## 10-20A CHANGE NOTICE

This is a summary of changes made during production of Multiphase Exciter Model 20A. Some of these changes are applicable to Model 10B and are noted accordingly. This information is presented in accordance with Central Electronics' policy to keep its customers advised of improvements.

CHANGE NOTICE

10B - 20A CHANGES

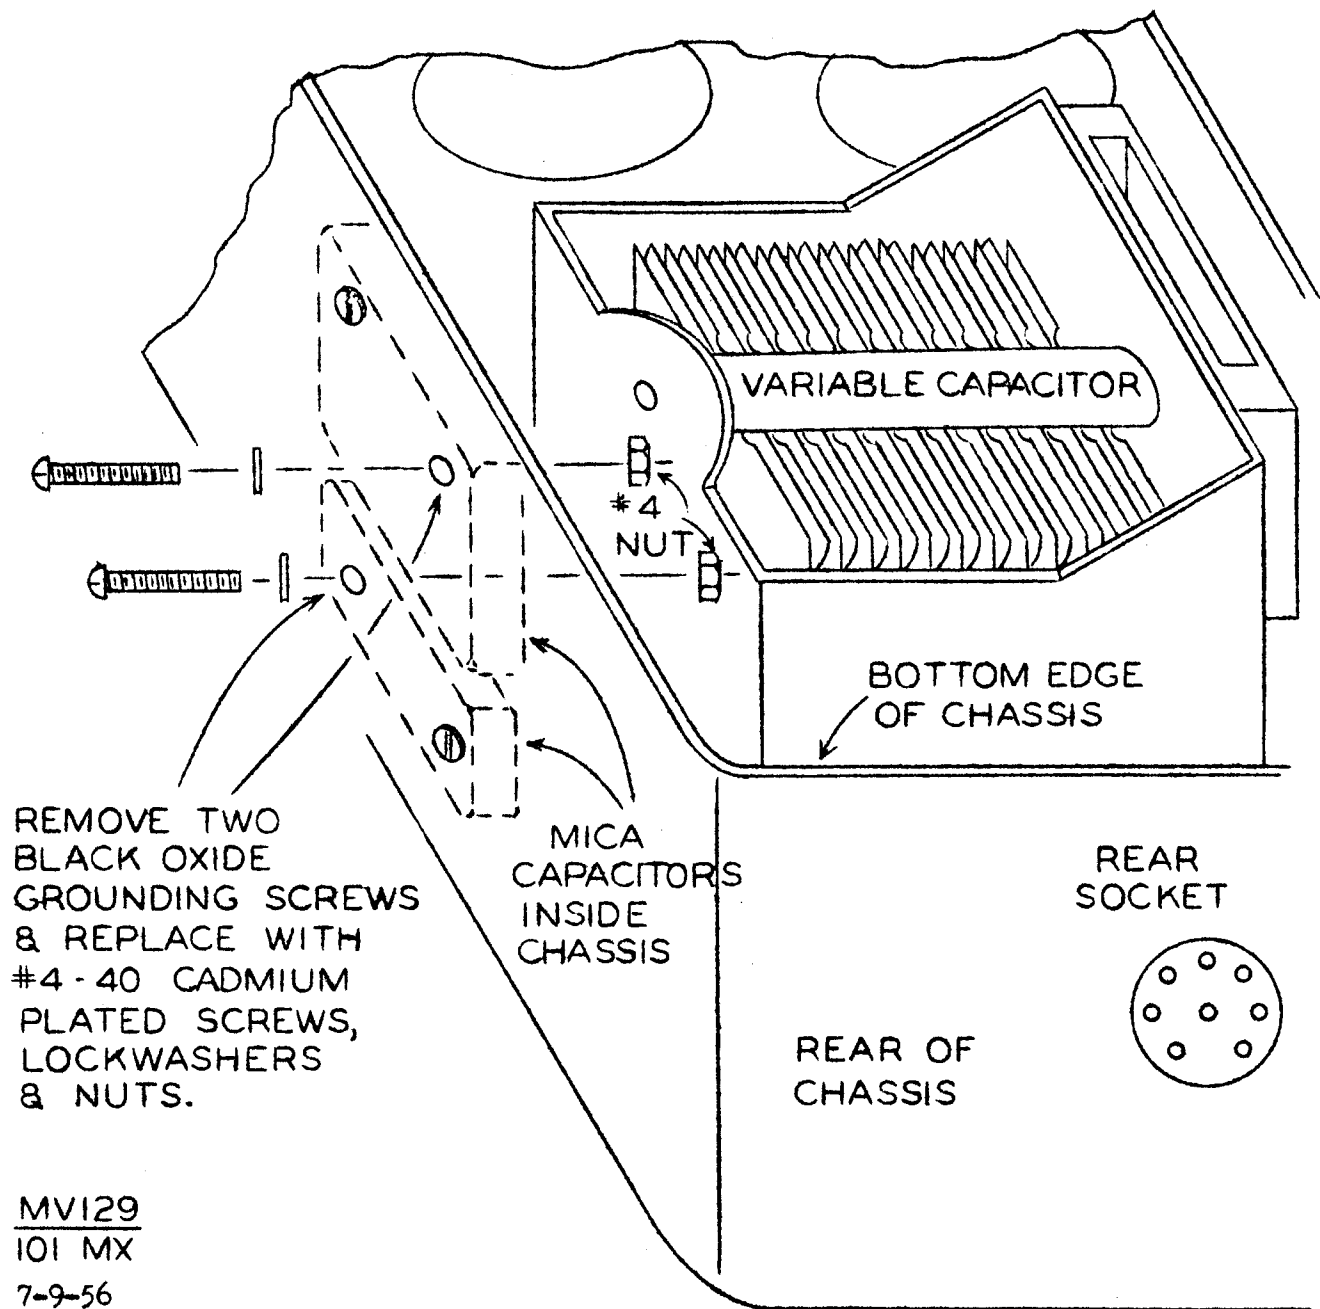
It is advisable to provide an additional low impedance ground path for the coaxial cable shields as shown on the left. This will prevent the exciter from self-oscillating, particularly on the higher frequency bands.

SCRAPE OFF COAX RIGHT WHERE VFO PLUGS INTO EXCITER AND PUT BRAID STRAP ACROSS AND GROUND STRAP TO 20A

## TEMPERATURE COMPENSATION OF THE VFO

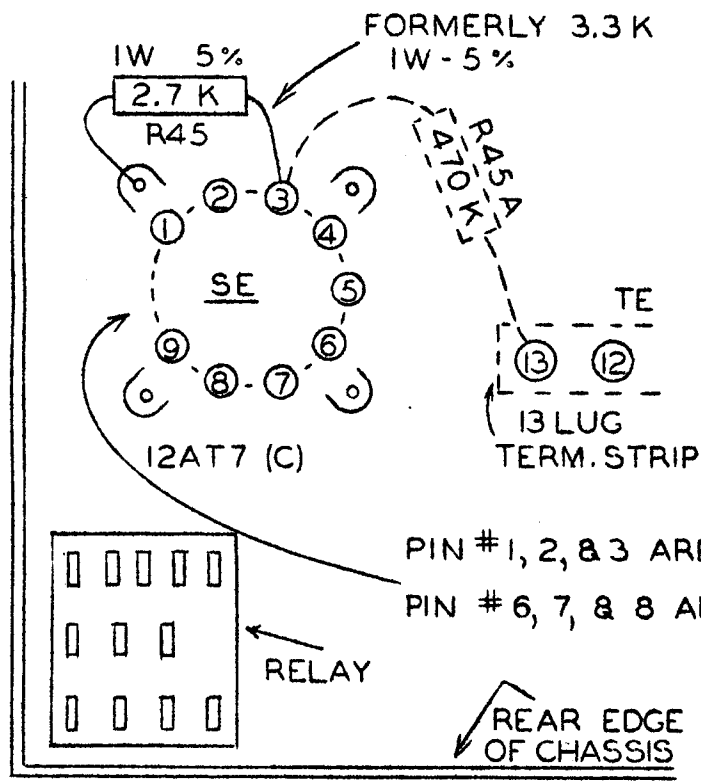
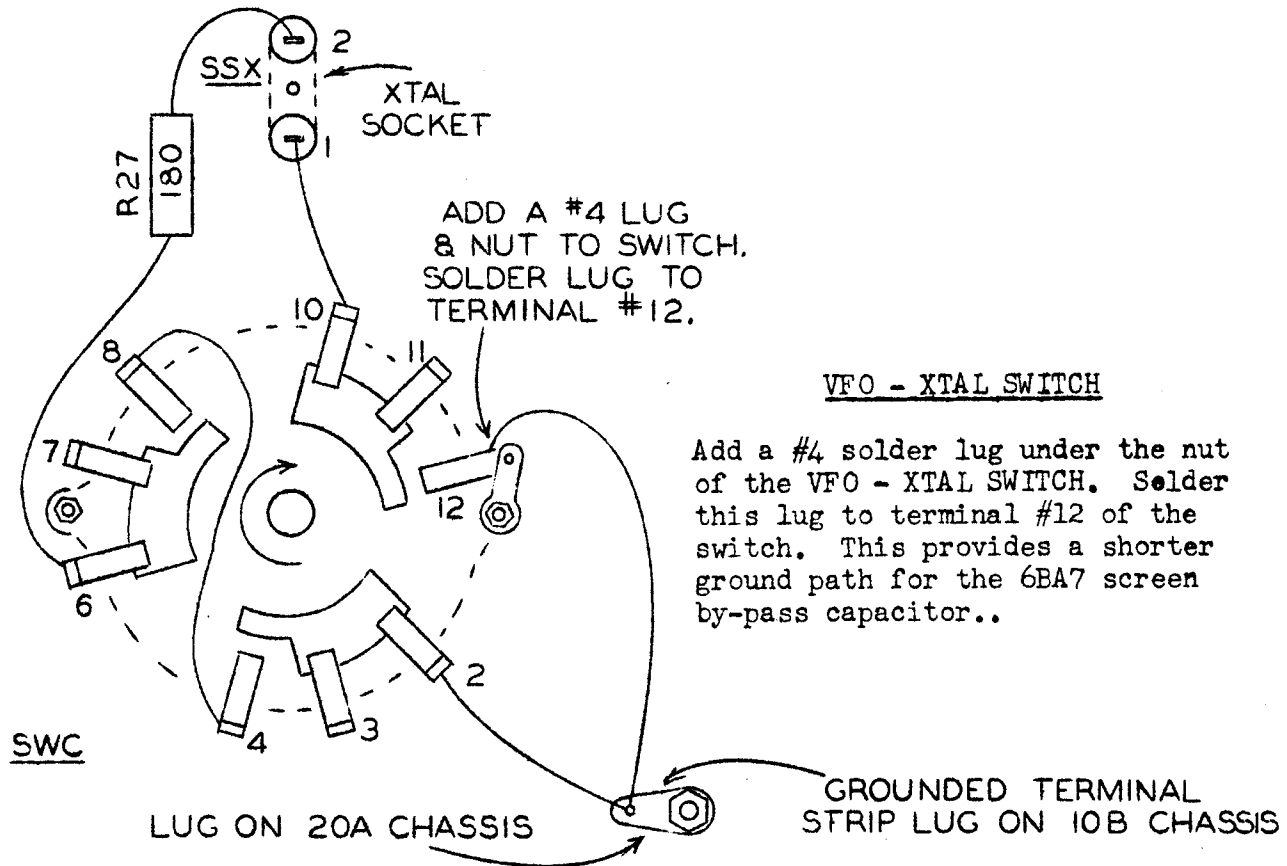
In order to achieve good stability in a reasonable period of time, the AVERAGE BC-453 requires a 10 mmfd. P100 temperature compensating capacitor, C26, inside the oscillator can. Be sure to remove the 3 mmfd. neg. 750 and change the 1626 grid capacitor to 180 mmf. zero temperature coefficient.

Occasionally some units may require no positive compensation at all, while others require 20 mmfd. P100.

It is recommended that all drift checks are made with the Exciter operating on the 40 meter band, where the fundamental VFO frequency is multiplied by three to 16 mc., so that any drift may be readily observed. If the 458 continues to drift higher in frequency 20 minutes after a cold start, when observed on 40 meters, another 10 mmfd. P100 should be added in parallel to the one already installed. If the 458 drifts lower in frequency instead, the 10 mmfd. P100 capacitor should be removed.

Each time a capacitor is added or removed, it will be necessary to readjust the large capacitor inside the oscillator can for proper calibration at 21,450 kc.

M154  
10B Change Notice  
9-5-56

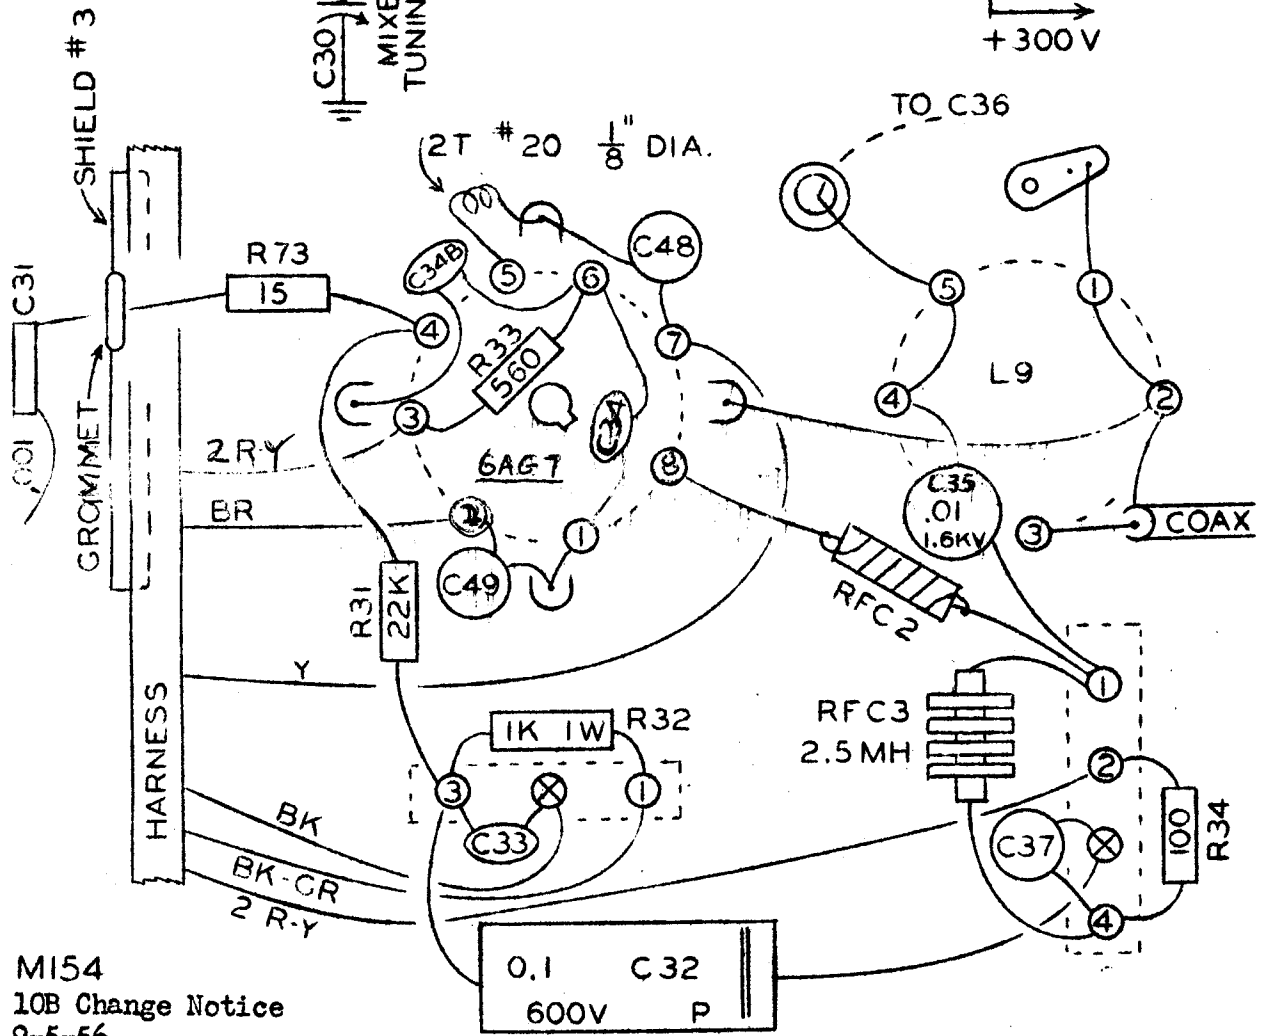
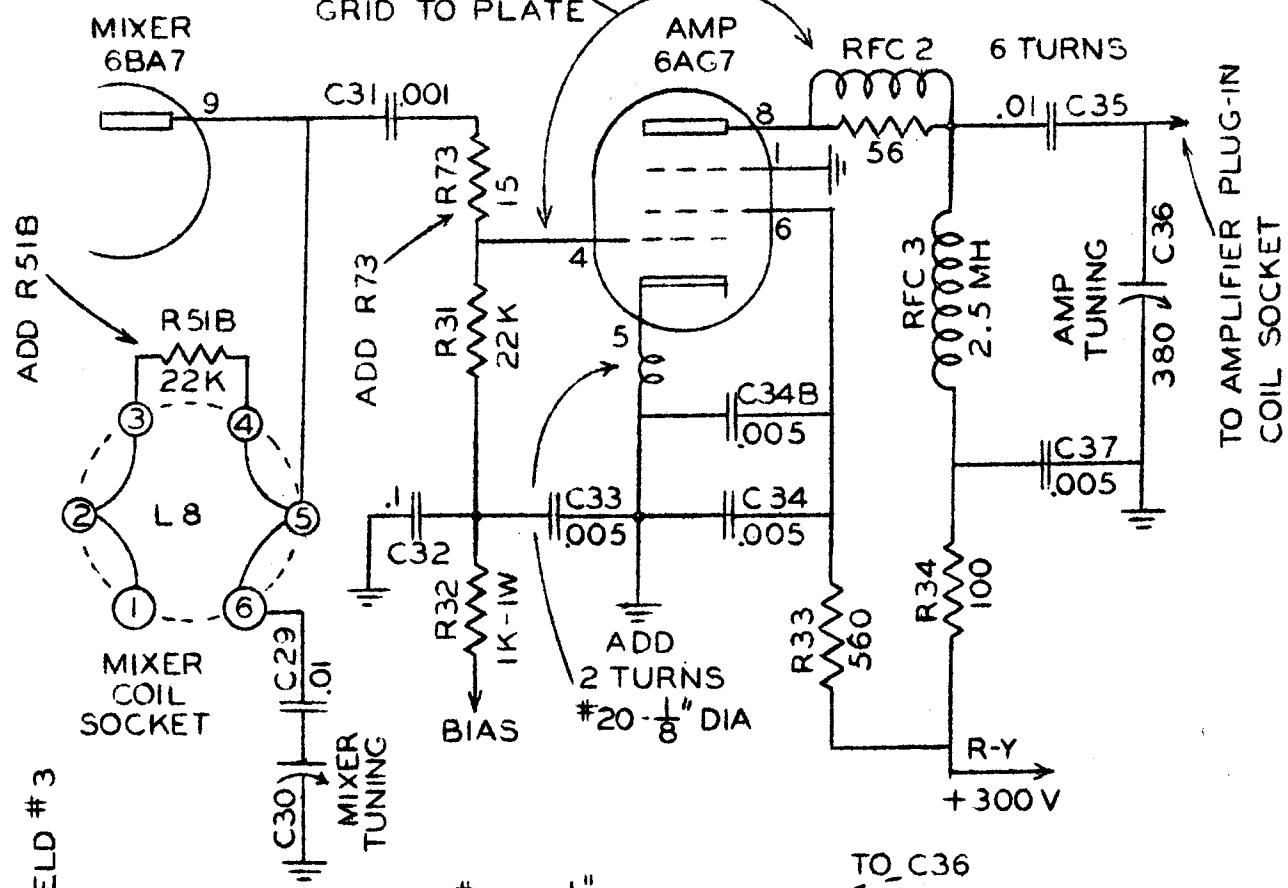
R45, in the cathode of the relay control tube, has been changed from 3.3K 5% to 2.7K 5% in order to lengthen the relay "hold-in" time and sensitivity. If the relay will not release after speaking into the mike, the value of this resistor should be increased.

MOVE PARASITIC SUPPRESSOR FROM GRID TO PLATE

KEYING CIRCUIT CHANGE

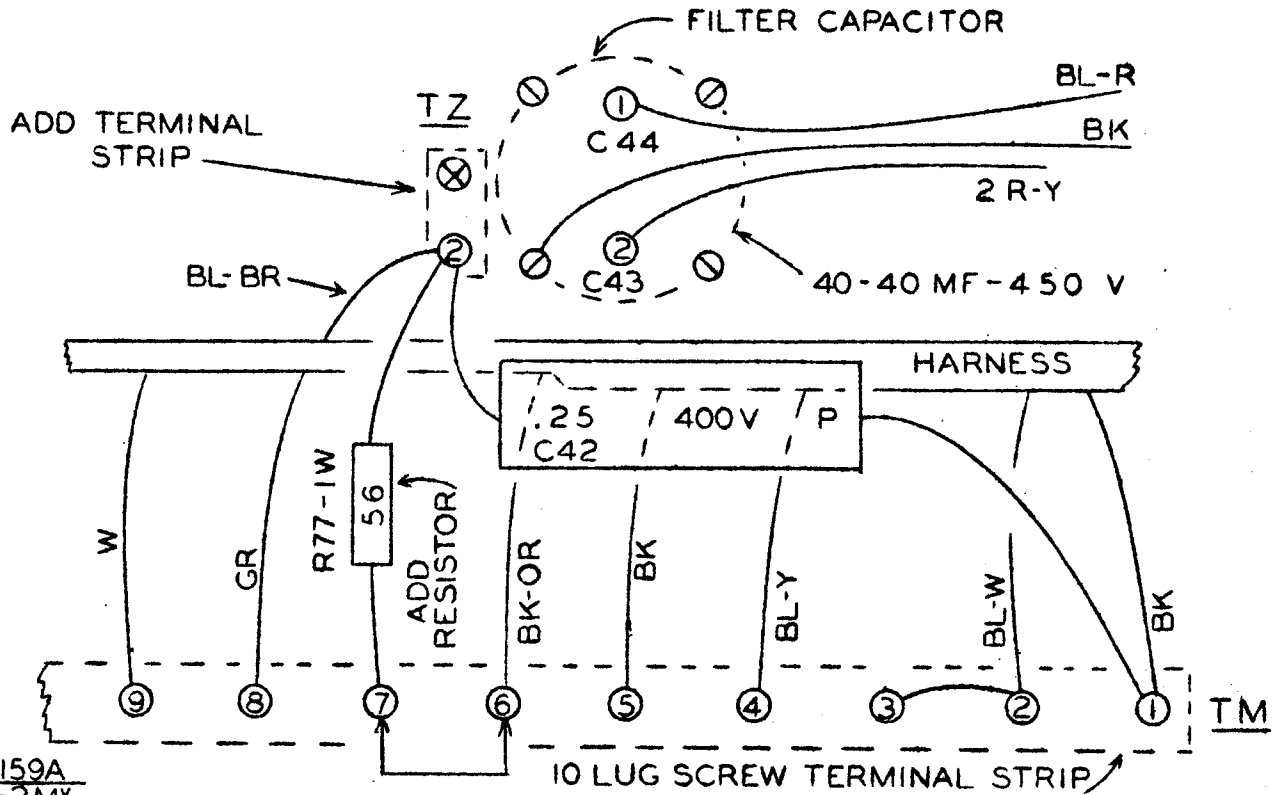
Mount a two lug terminal strip TZ together with the filter capacitor plate as shown.

The Blue-Brown lead from harness goes to terminal strip TZ lug #2 (NS).

A 56 ohm 1 watt resistor, R77, from two lug terminal strip lug TZ #2 (NS) to lug #7 of 10 lug rear screw terminal strip TM. Capacitor C42 (.25 mfd.) goes to terminal #2 of TZ two lug strip (S).

NOTE: On units below serial No. 7300, C42 was connected to #7 of 10 lug rear terminal strip TM.

The grounded terminal #1 of TZ is not wired.

## AUDIO CONNECTION FOR OSCILLOSCOPE

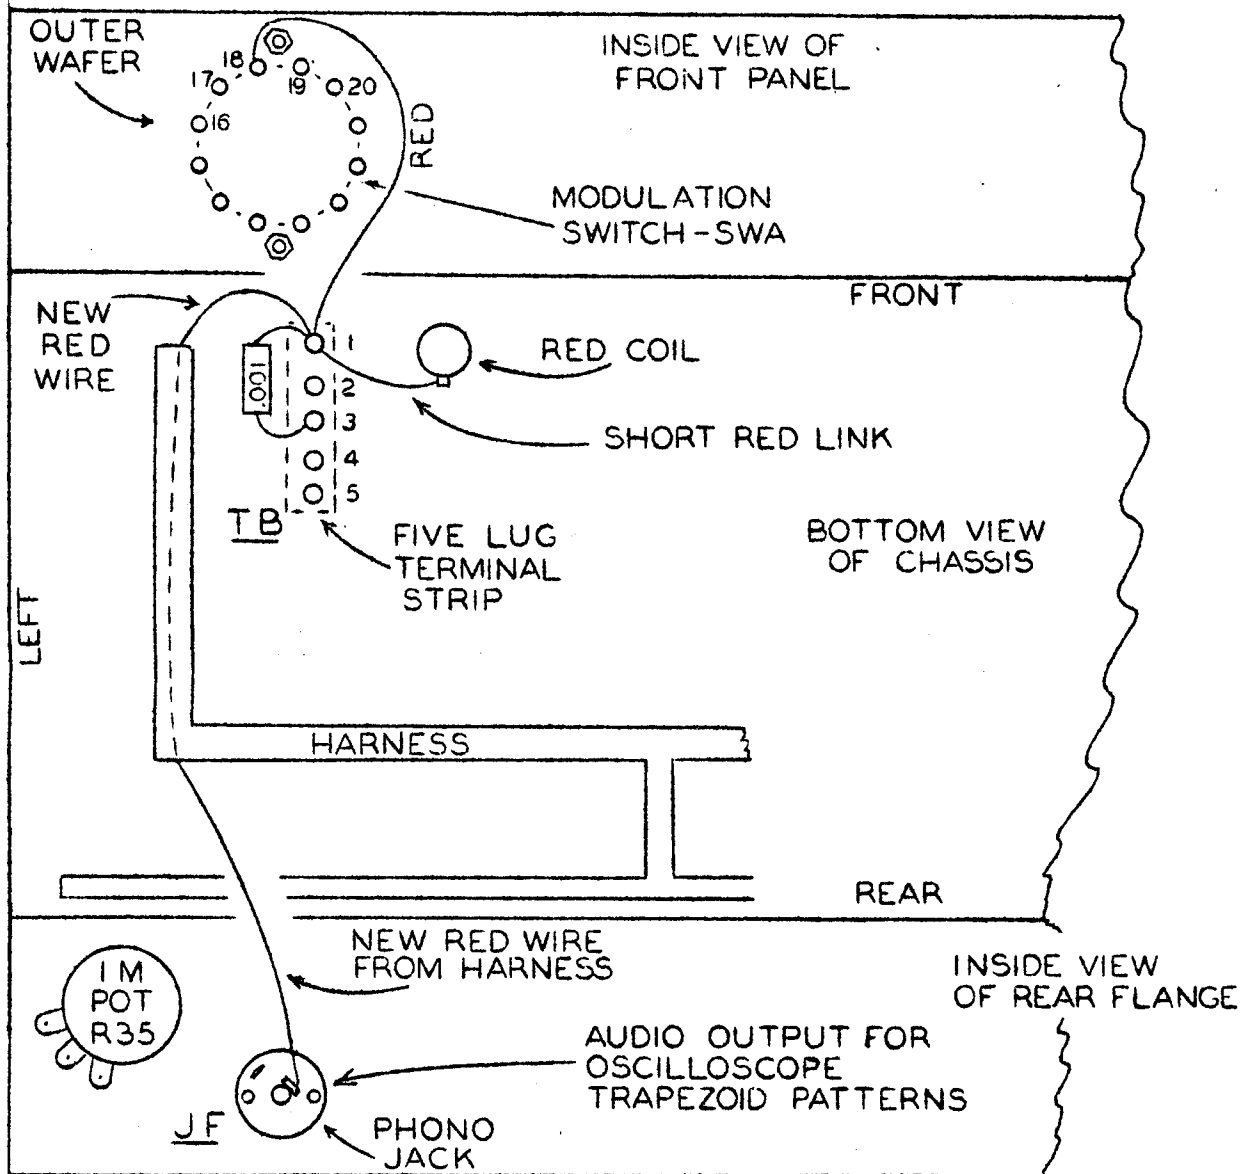
A phono jack has been added to the rear of the chassis, which connects to the output of one of the modulators. This jack can be used to supply the audio voltage to an oscilloscope, such as the MM-1, for obtaining trapezoid patterns.

Mount the phono connector on the rear of the chassis with #6 hardware, as shown below. The red wire from the harness connects to terminal strip TB, Term. #1, near the front of the chassis. Solder the other end of this lead to the phono jack at the rear of the chassis.

This red wire is included in the harness in all Exciters which have the letter "C" following the serial number. On earlier Exciters the holes must be drilled for the connector and the red wire must be added.

AF INPUT JACK CHANGE

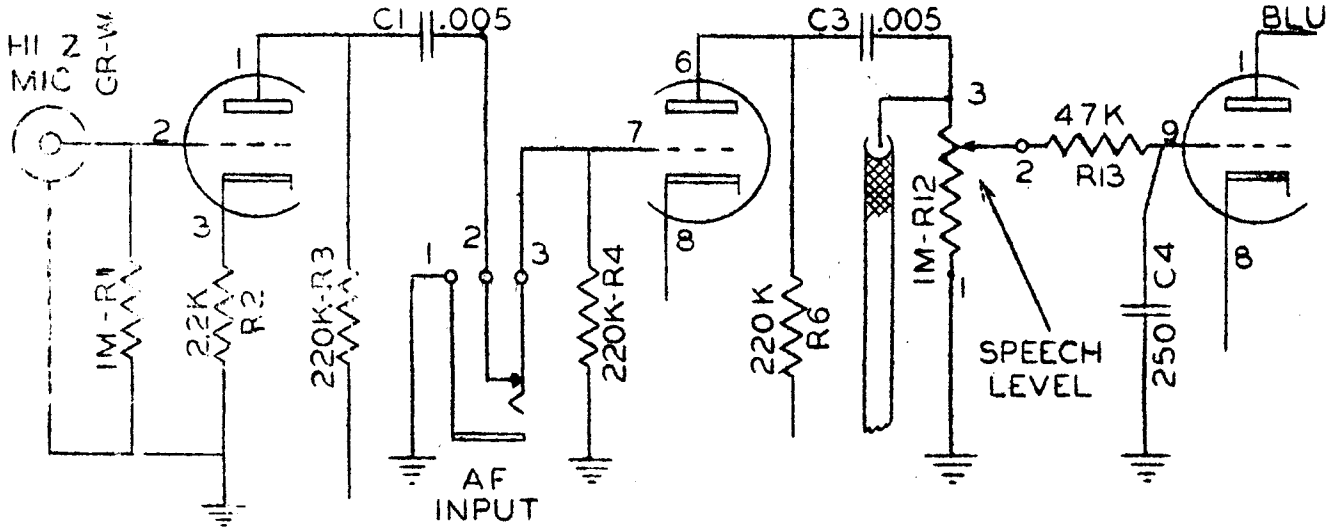
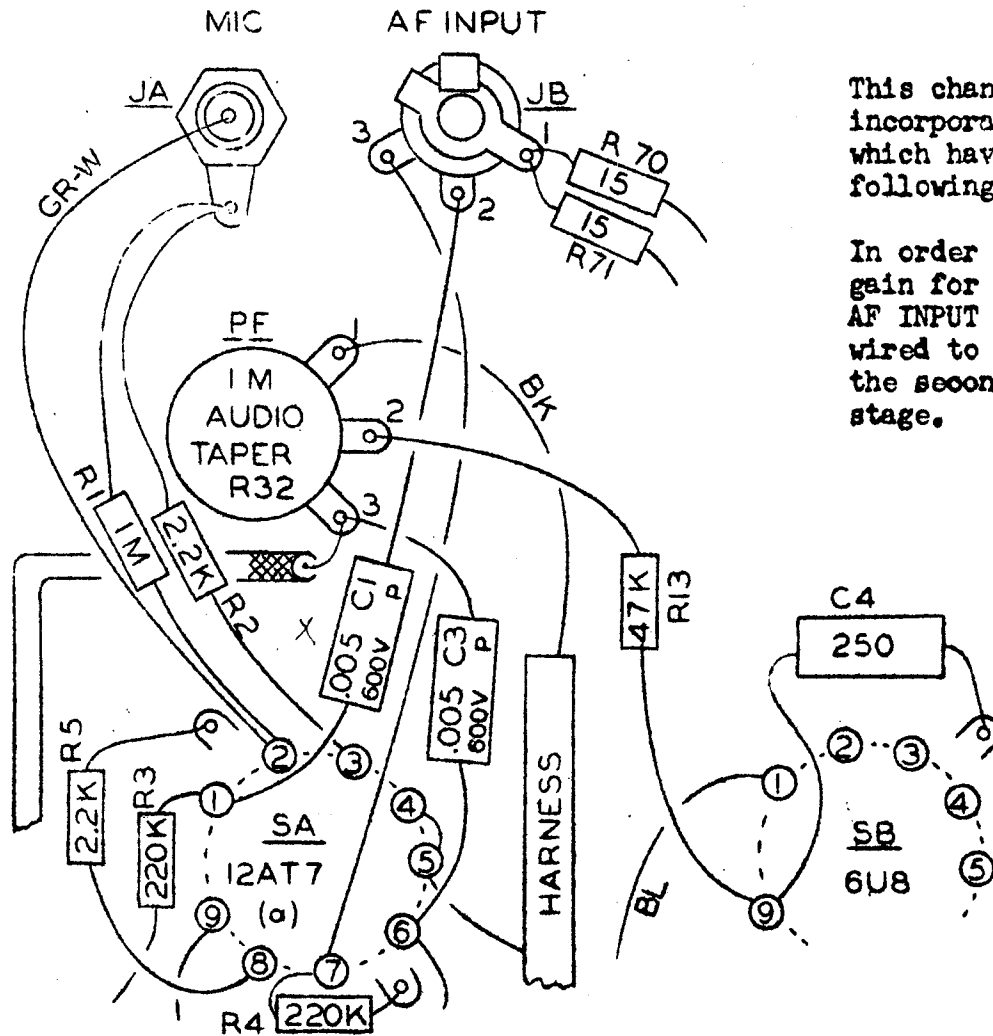
This change has been incorporated in all Exciters which have the letter "C" following the serial number.

In order to provide more AF gain for phone patch operation AF INPUT jack JB has been wired to the input grid of the second speech preamplifier stage.
